# Clearfield City Council Work Session

LOTUS ANTHEM  
Development Agreement  
1<sup>st</sup> Addendum

# Clearfield City Council Policy Session

TOWNS AT UNIVERSITY PARK  
Final Subdivision Plat  
FSP 2022-090046

# Park Side Townhomes

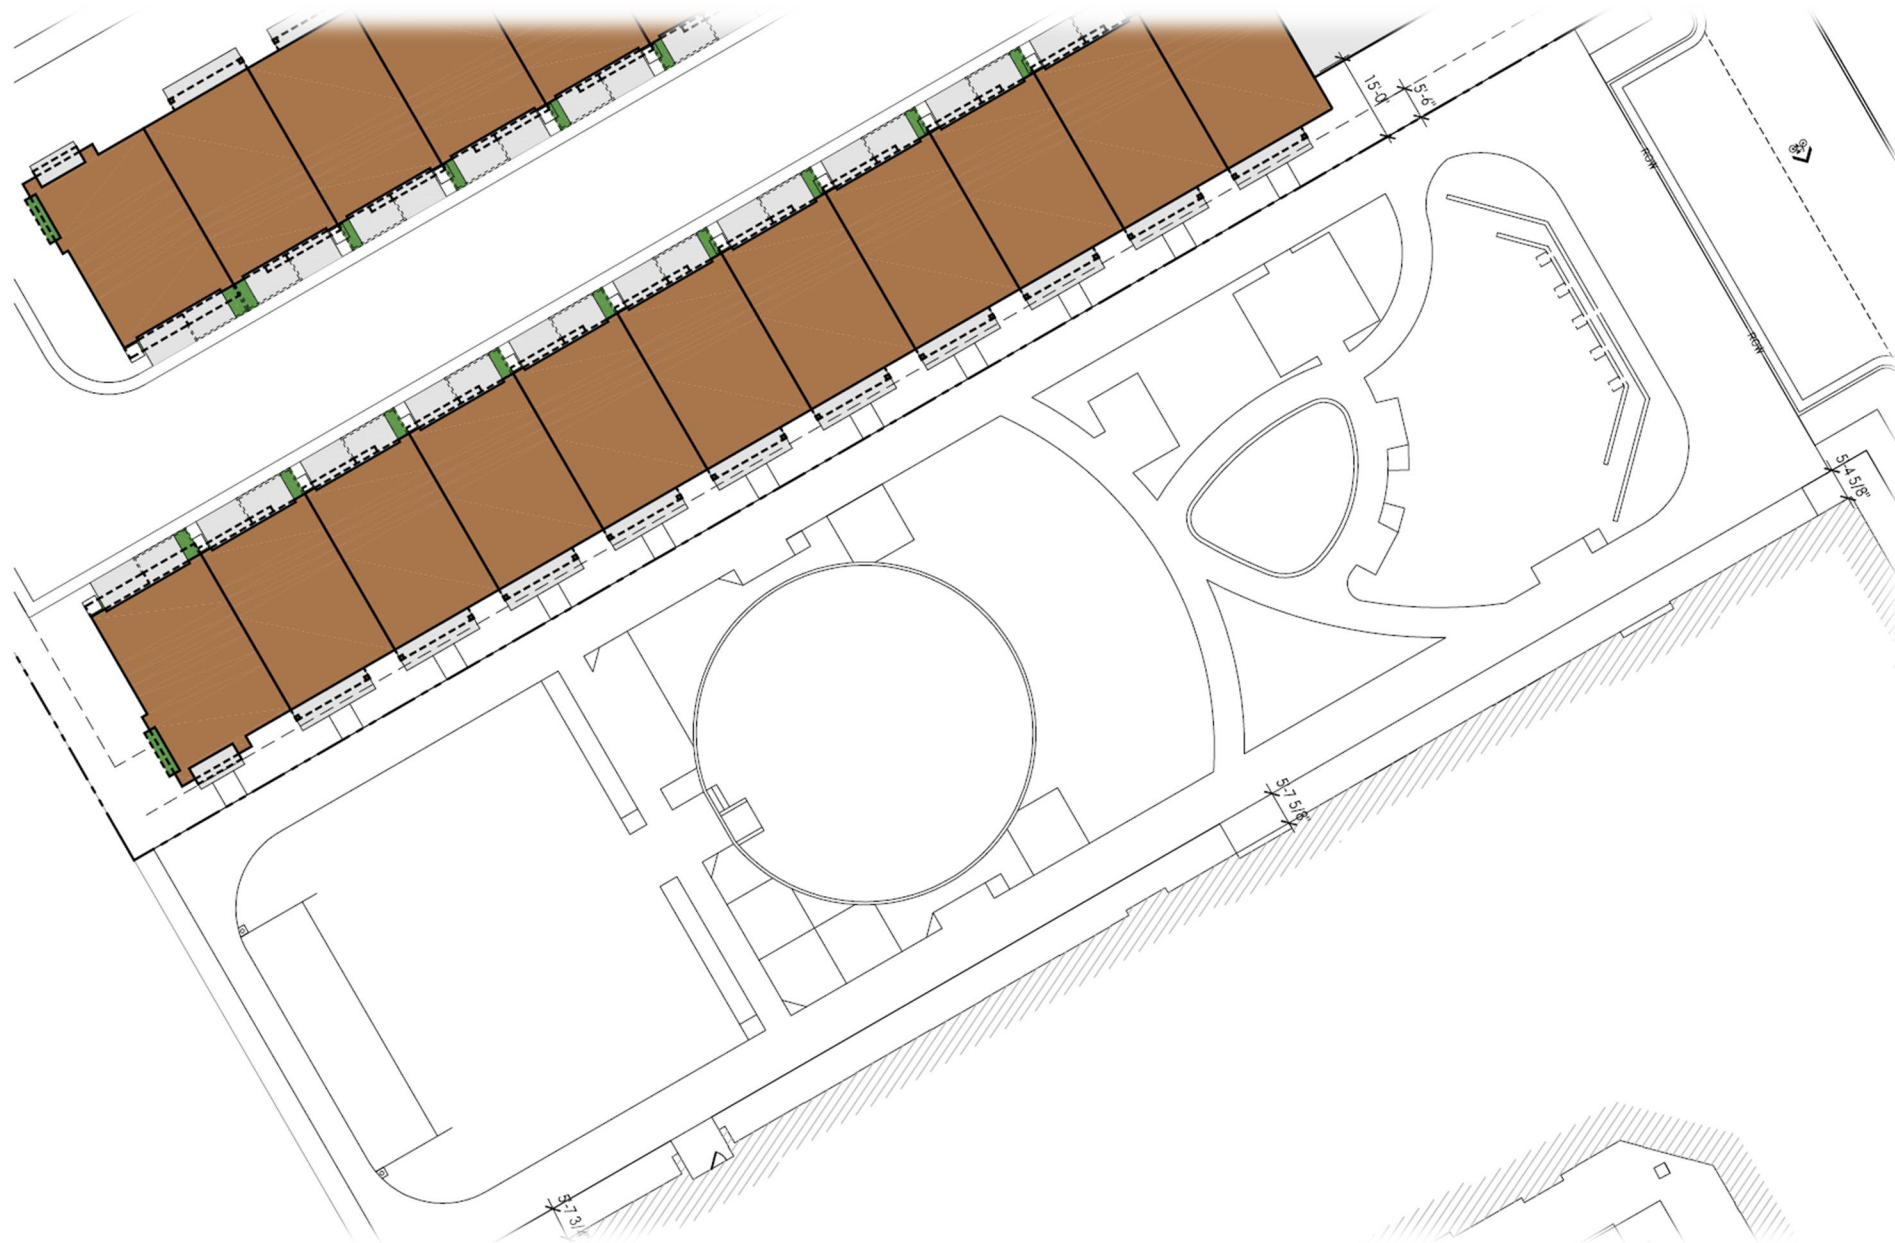
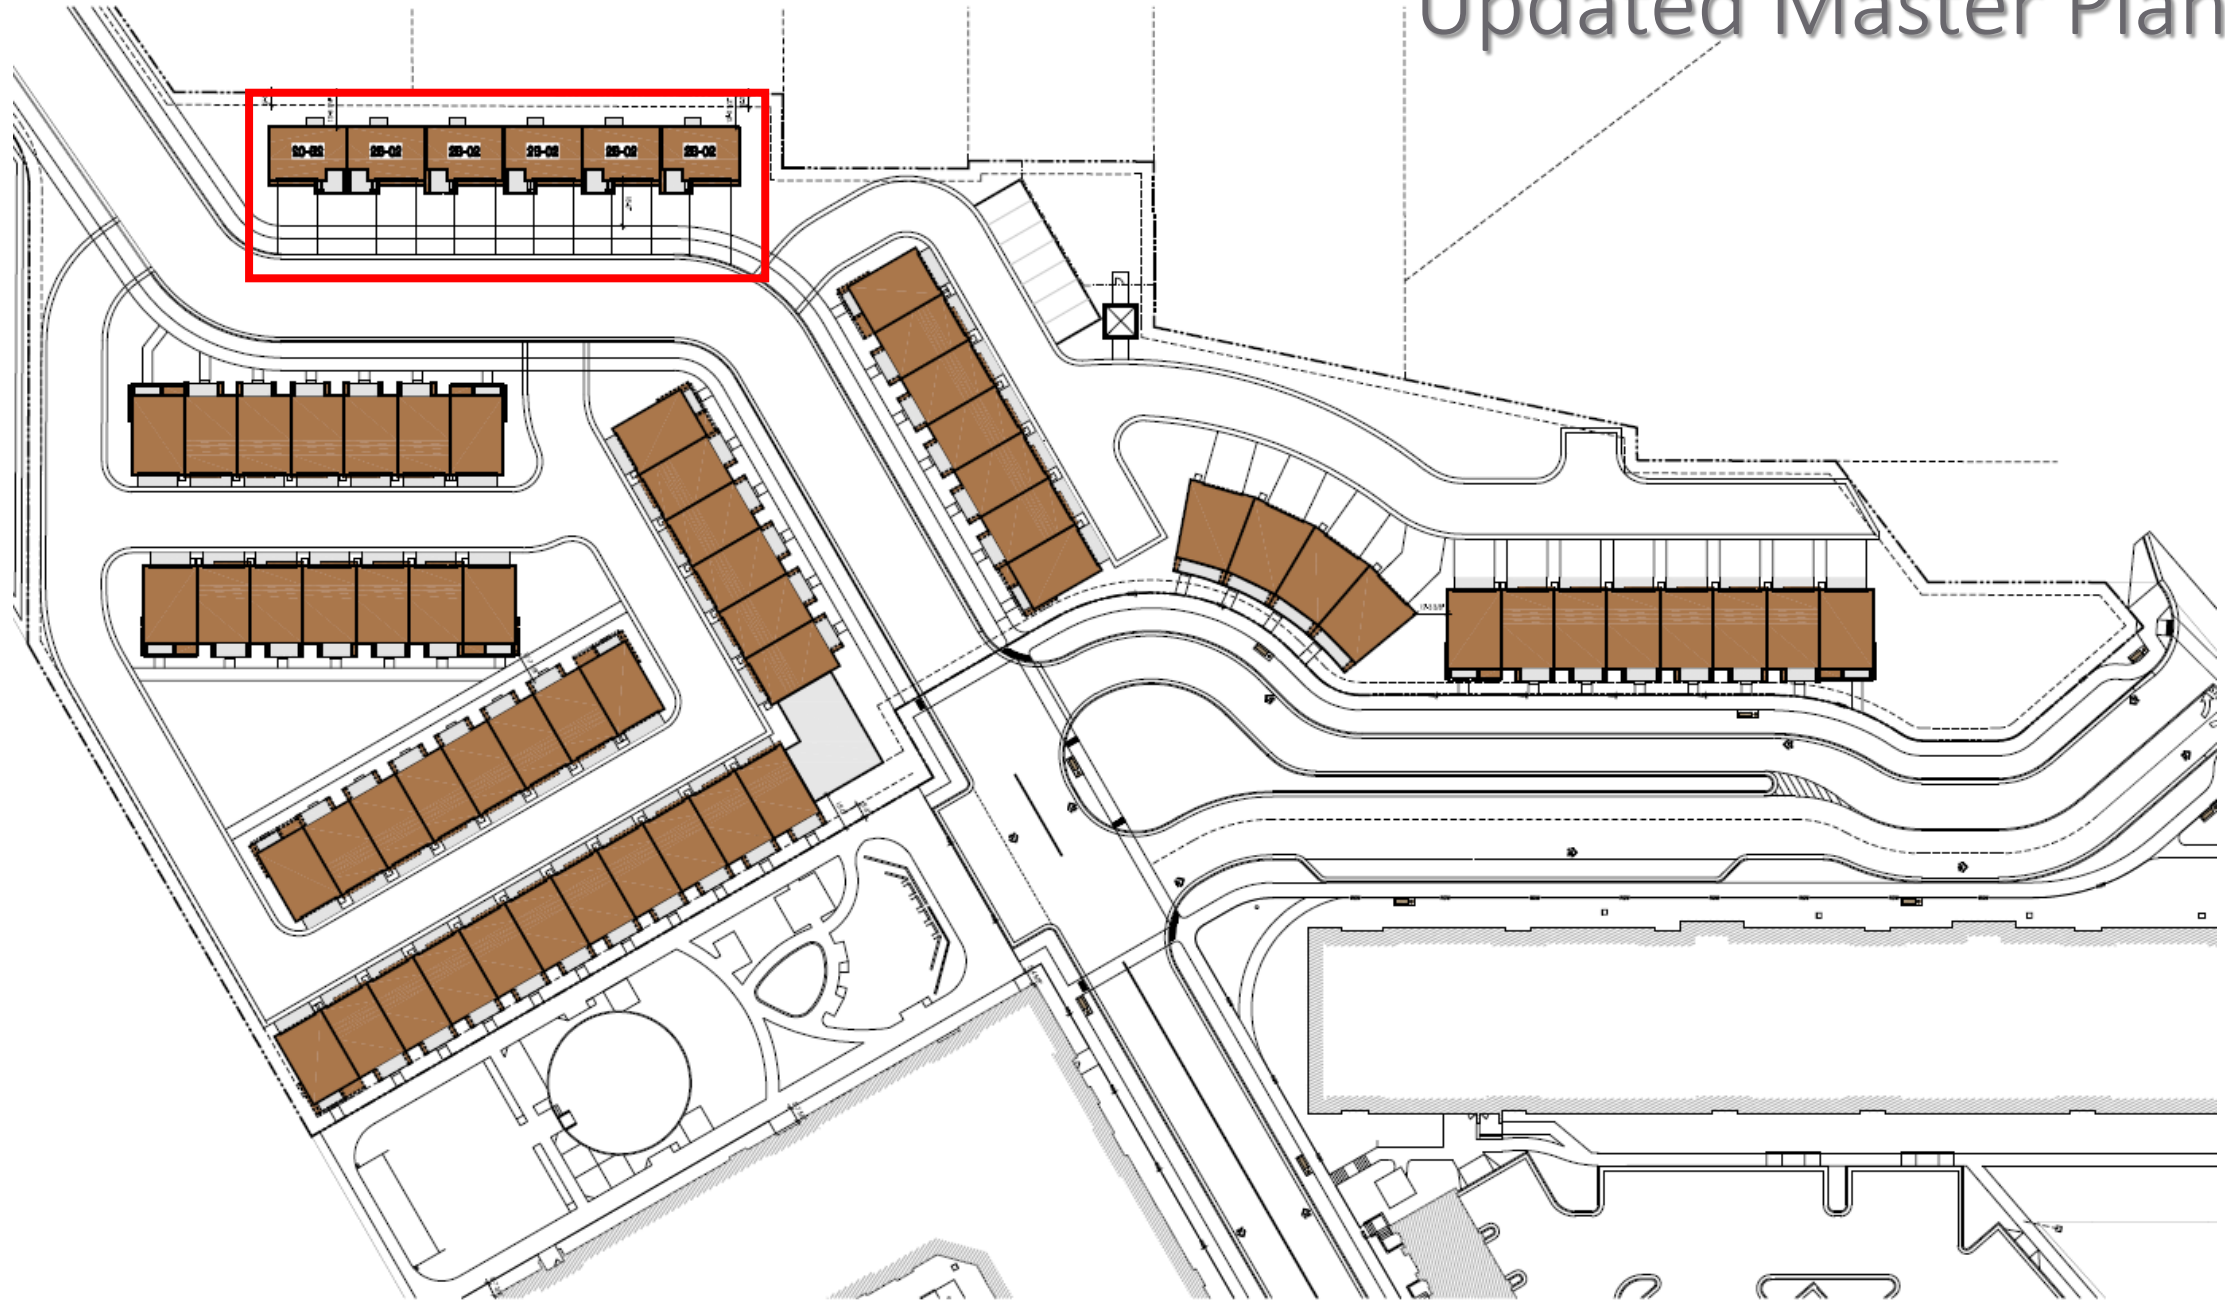
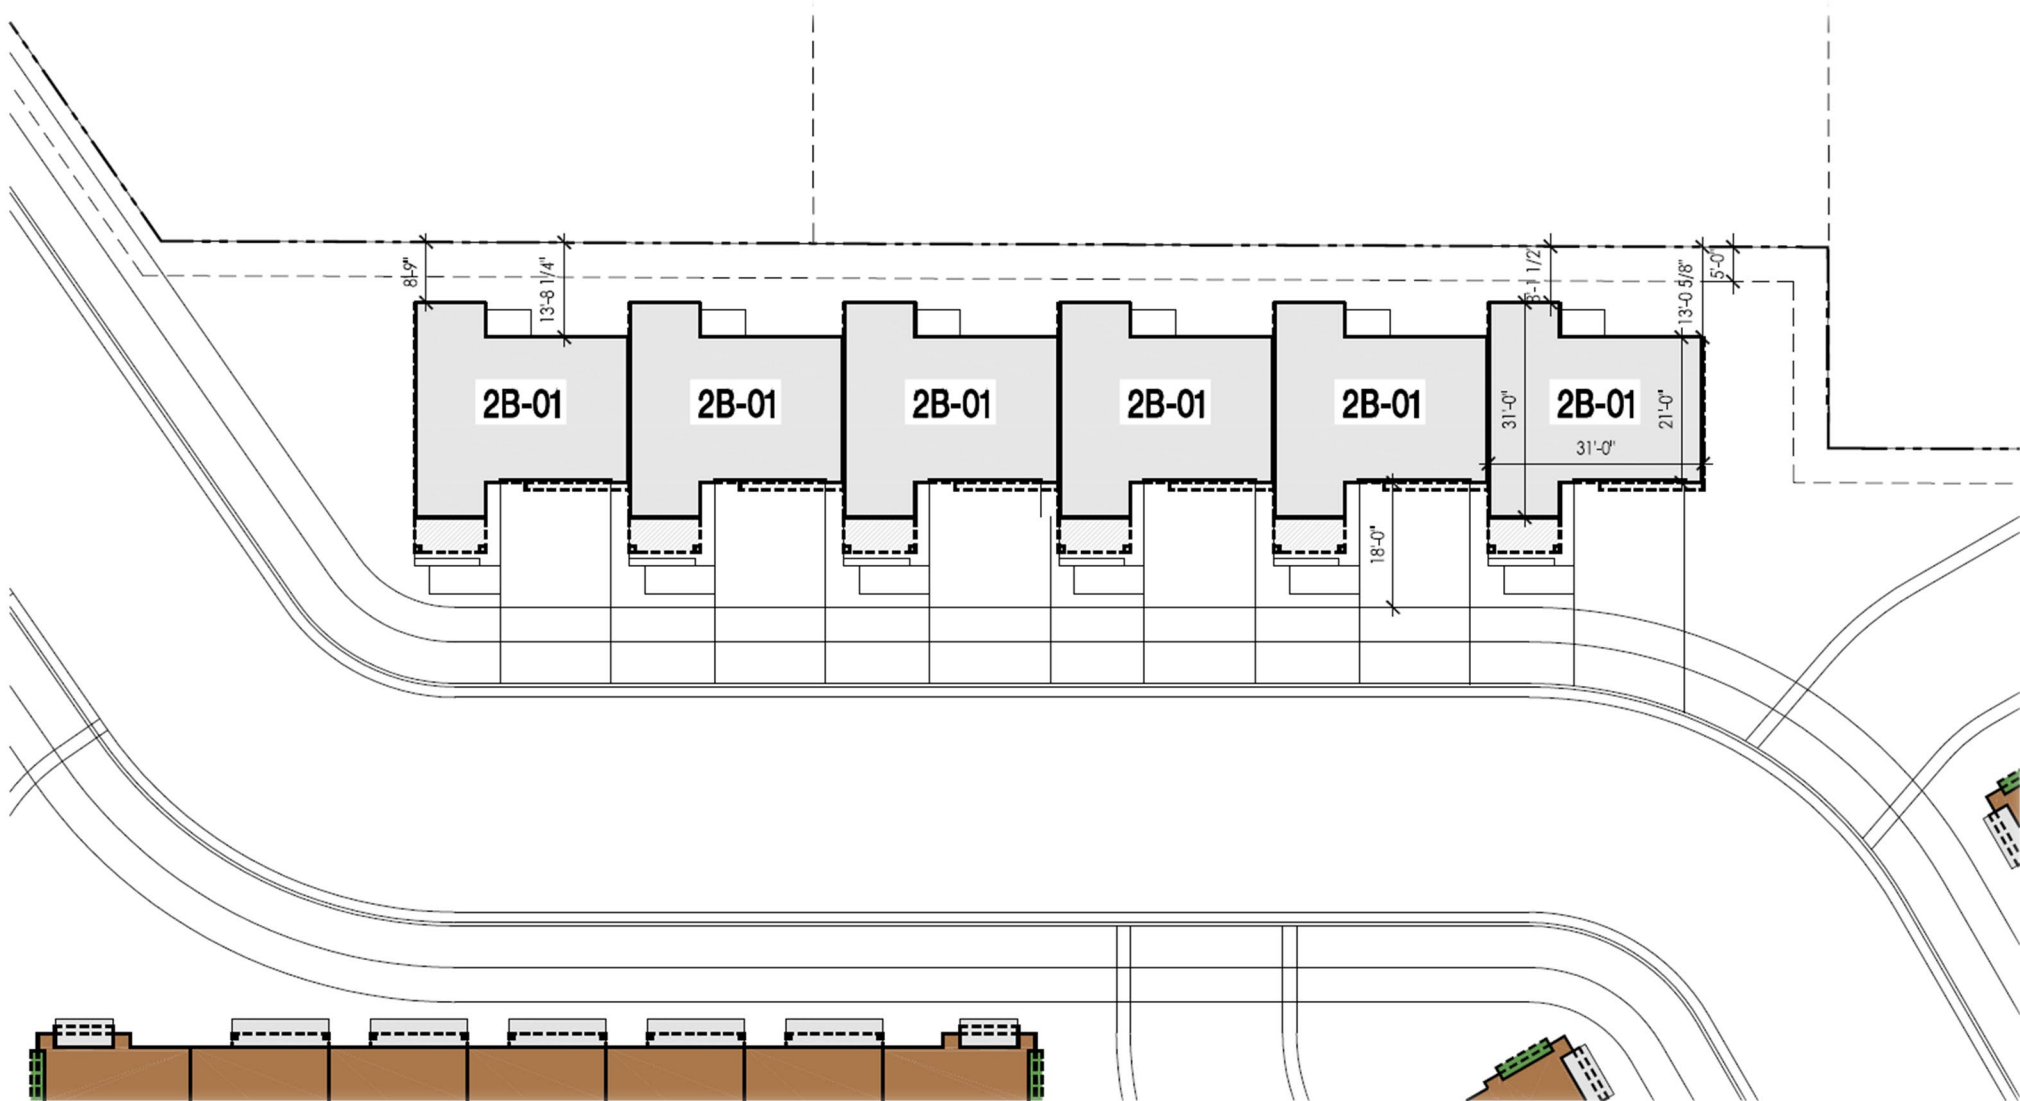
1. *Front setback for townhomes facing park.*
  - *Code requires 15' if not facing a street.*
  - *Lotus would like to match setback of the apartments on the south side of park.*
2. *Required occupied space of 30' deep required on all full floors.*
  - *With wider townhome units, the unit depth is less than 30'.*

| Standard:                                                                                  | Requested Modification:                                                                                                                        |
|--------------------------------------------------------------------------------------------|------------------------------------------------------------------------------------------------------------------------------------------------|
| Townhouse Building Type<br>Maximum Building Width: 6 units                                 | Townhouse Building Type<br>Maximum Building Width: 12 units                                                                                    |
| Townhouse Building Type<br>Required Occupied Space: 30' deep on all full floors            | Townhouse Building Type<br>Required Occupied Space: 20' deep and 30' width on all full floors of front load, front entry units                 |
| Townhouse Building Type<br>Front Build-to Zone: 5' to 15' (10' min if not facing a street) | Townhouse Building Type<br>Front Build-to Zone: 5'6" setback for park facing units (match setback of apartments on the south side of the park) |
